Site Plan Review Committee (SPRC)  
Staff Report for:  
**Crystal Plaza 5 (Site Plan #SPLN20-00015)**

**SITE PLAN REVIEW COMMITTEE  
MEETING AGENDA**

**Item 1. Crystal Plaza 5 (2250 Crystal Drive / 223 23rd St. S.)** **7:00pm–9:00pm**  
(RPC#s 34-020-003, -017, -018, -265)  
Planning Commission and County Board meetings to be determined.  
*Michael Cullen (CPHD Staff)*

**SUMMARY:** The applicant, JBG Smith, proposes to redevelop the site (“Crystal Plaza 5”) located at 223 23rd Street and 2250 Crystal Drive and construct two new multifamily residential towers with ground floor retail space.

**Figure 8: Public Open Space Map and 23rd Street Plaza Concept**

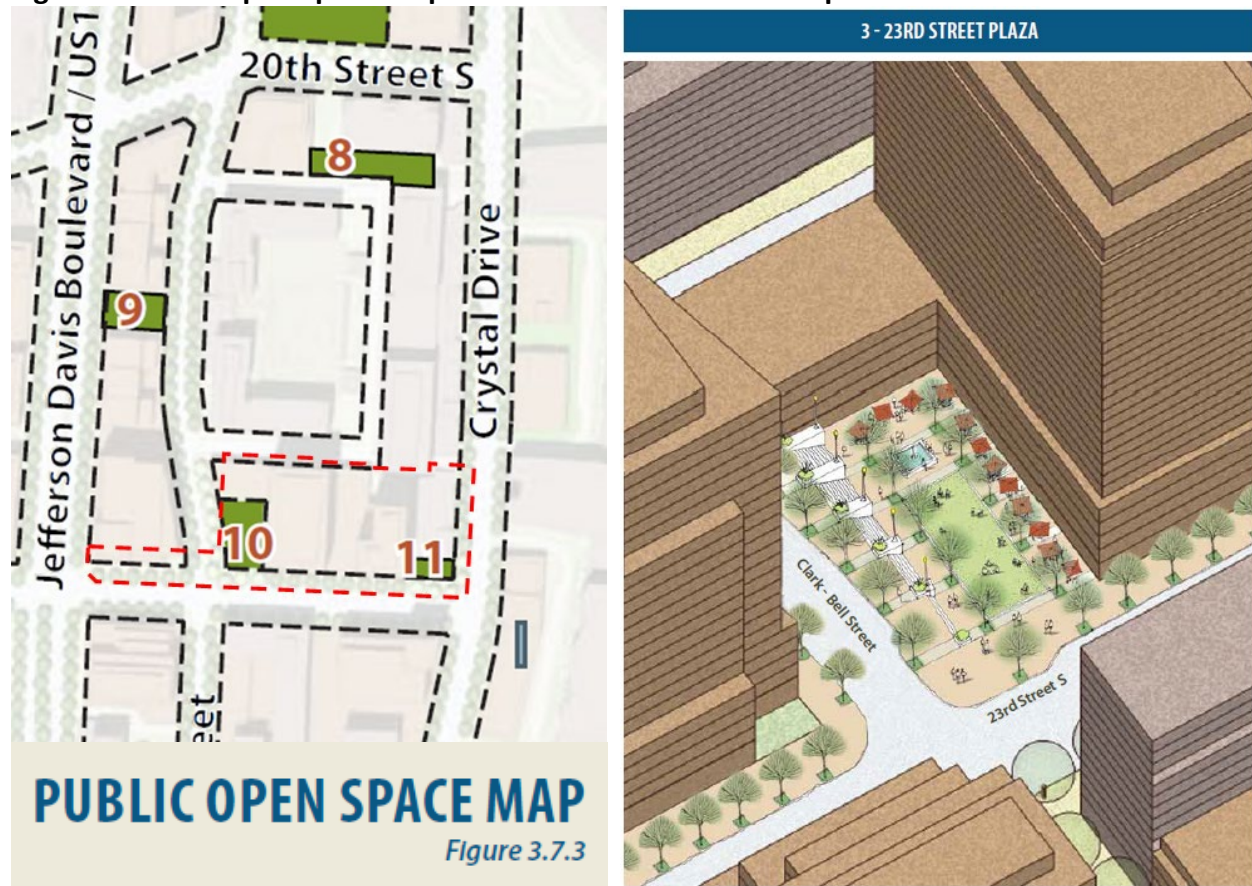
The applicant is proposing a phased Open Space #10 with an initial phase that is 33% smaller than the 13,000 square feet called for in the Sector Plan at 8,670 square feet. This initial phase would be designed and constructed as part of this site plan review, while the final phase would be subject to a future development application of the adjacent Crystal Plaza 6 site and a separate public review process.

The applicant proposes an alternative location for Open Space #11 by creating an approximately 5,000 sf public plaza connection to the Underground entrance from Crystal Drive on the north side of the 2250 Crystal Drive Building; however, the total space provided is significantly larger than the 3,300 sf called for in the Sector Plan and the proposed design is consistent with the landscaped plaza referenced in the Sector Plan. This public open space would also be designed and constructed with this site plan development.

**Figure 10: Revised Open Space #10 Lawn Concept**

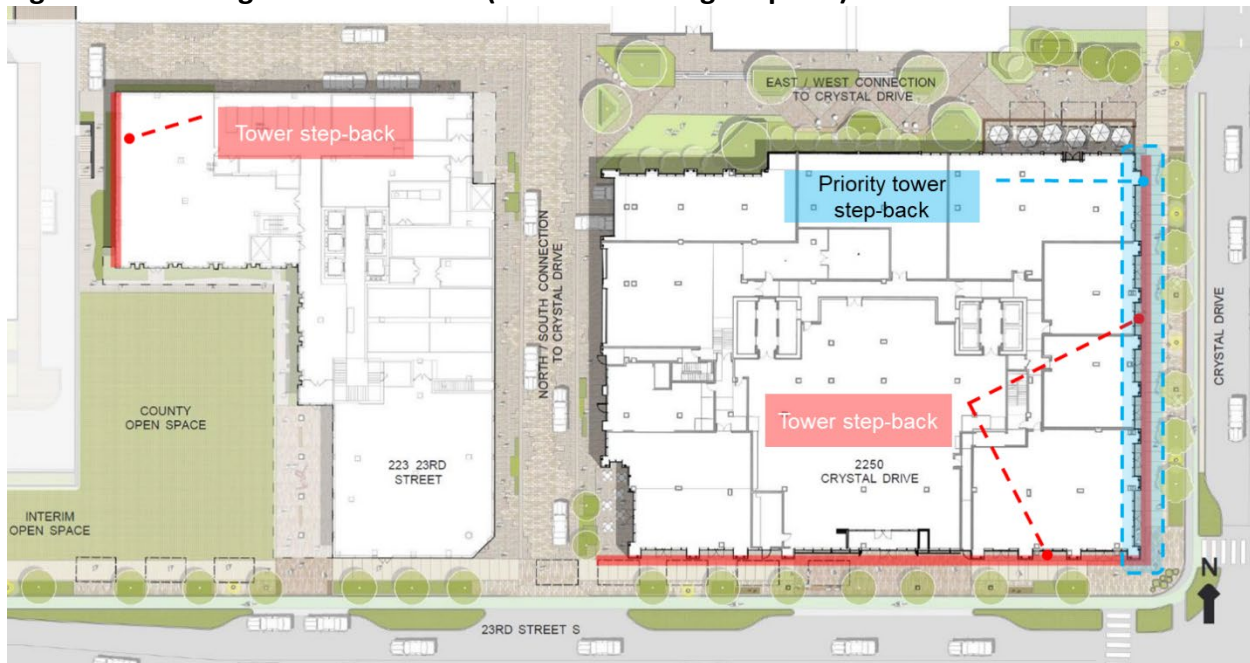
Open Space Details: although the full Open Space #10 area will not be achieved with this project alone, staff recommended that additional design elements be incorporated into the 8,670 sf space that would be delivered with this project, including: consideration of less intensive landscaping to frame the space and add interest compared to a simple grass lawn area; and improved pedestrian pathways to both the retail frontage along Open Space #10 and to stairs shown on the northwest side of the site that would provide access to the interior of the block. These issues have largely been addressed in the most recent submission, as shown in Figure 10 below.

**Figure 12: 223 Building Top Design (Penthouse and South Wing)**

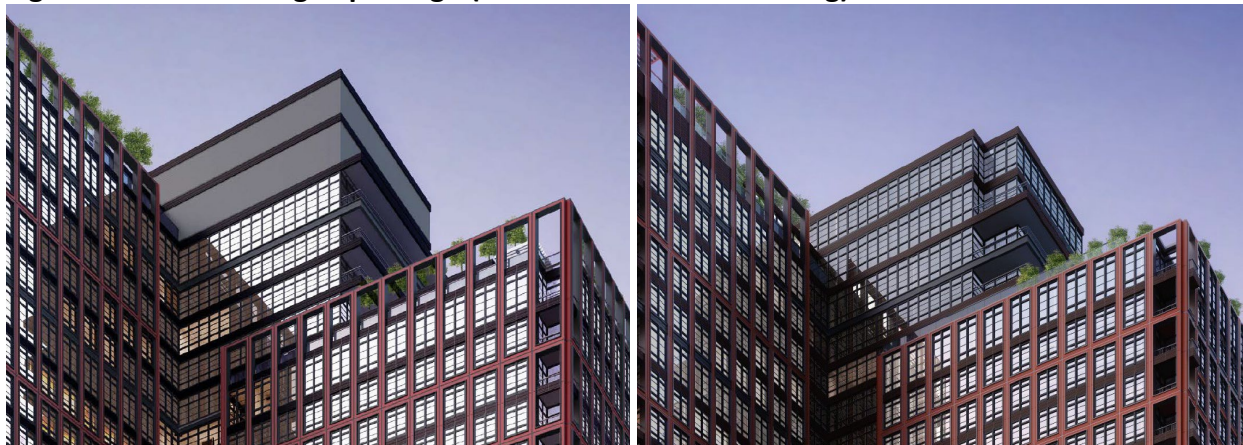
*223 23rd Street Building:* although a minimum step-back of approximately five feet has been implemented along the 23rd Street frontage, the applicant still fails to account for the future Clark-Bell Street alignment in the proposed western building face with no tower step-back or other tower sculpting. The central tower mass, which contains mechanical penthouse space, now features an improved glass façade treatment of a quality and character consistent with the building's tower façade; however, the south wing of the building, fronting 23rd Street, now features less articulation than the preliminary site plan submission design. Previously, as shown in Figure 12 below, this wing featured a treatment similar to the western building wing with a step-back of the top floor footprint that created a sense of openness and transparency.
